## Label location statement

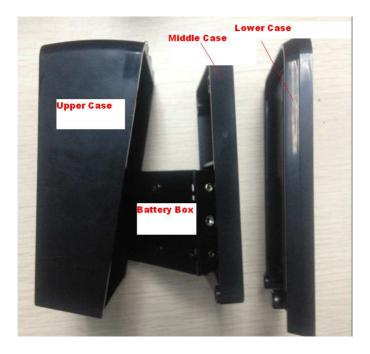
1. The battery cover should be called Lower Case, please see the following figure as stated:

The purpose of the Middle Case is used to fix the battery box and the PCB, and the Lower Case is the last action for assembling the units.

2. If the label stick in the Middle Case area, the label will block the buzzer & reset key (please see the following figure)

3. So that label position as below stated is the most appropriate.
